**25th IHO-TSMAD Meeting
Tokyo, Japan, 15-18 January 2013**

Considerations on the implementation of Annex 1 to TSMAD Terms of Reference

Submitted by:	IHB
Executive Summary:	This paper reviews the implementation of the procedure to manage the Use of the Object Catalogue for ENC and the Encoding Bulletins.
Related Documents:	Final minutes of HSSC2 Final minutes of HSSC3 TSMAD Terms of Reference as amended at HSSC3 IHO CL 90/2012 of 29 October 2012

Annex 1

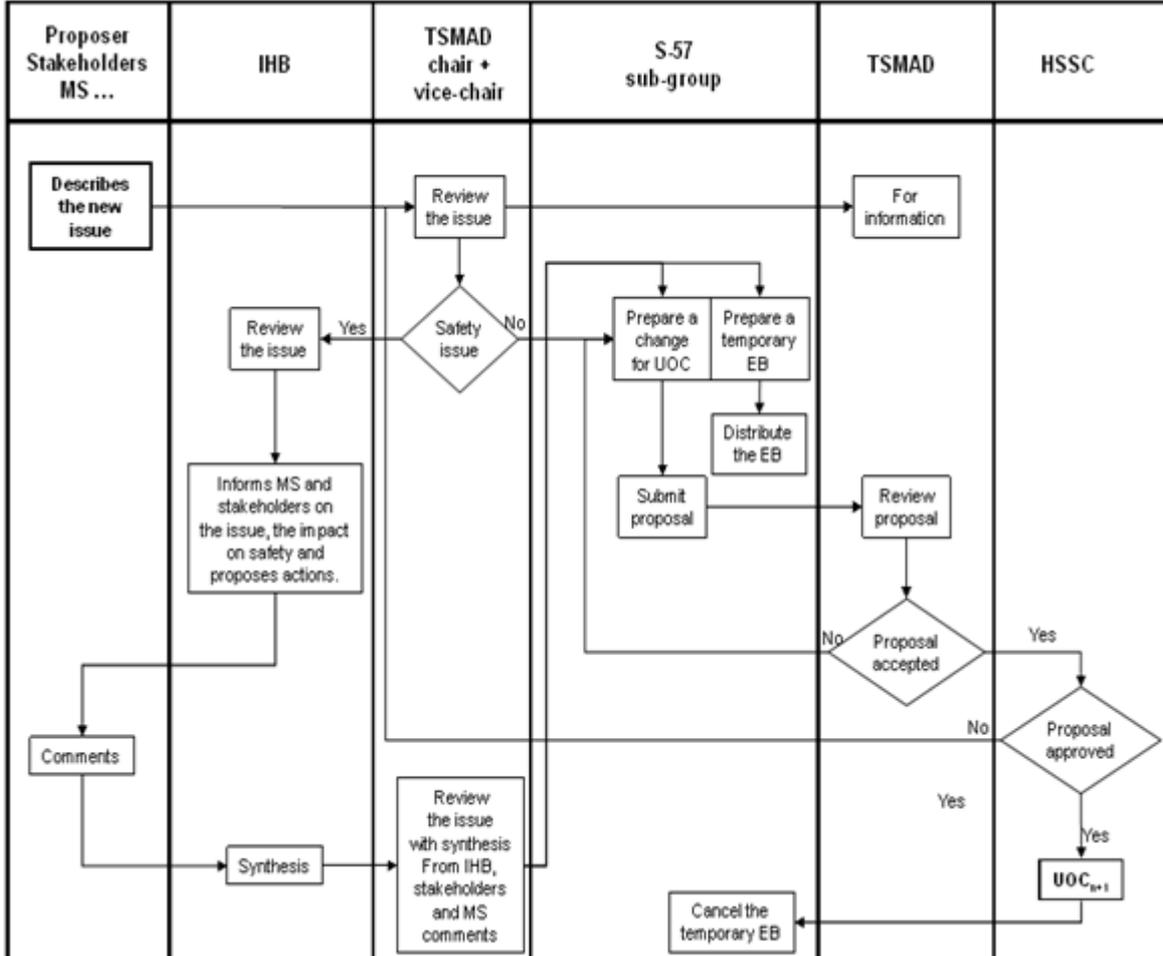
The procedure in the Annex 1 of the TSMAD TORs seems not to be clear. Following strictly the arrows in the diagram indicates that in safety critical issues the Members States and Stakeholders should be informed and feedback from them to be reviewed. After that the issue returns back to the S-57 sub-group for preparing and releasing an EB, if needed. In our understanding only a limited number of experts have been contacted on this issue (mainly S-57 sub-group). However the CL 90/2012 request actions from all RHCs, from all MS and even from non-member states.

To avoid this kind of cases in the future we propose to clarify the TSMAD TORs for specifying more clearly the process of issuing urgent EBs. Also process shown in Annex 1 should be clarified. The criteria for safety critical issues should be defined. It should be specified that real encoding clarifications to be forwarded via EBs and portrayal clarifications via Portrayal Bulletins.
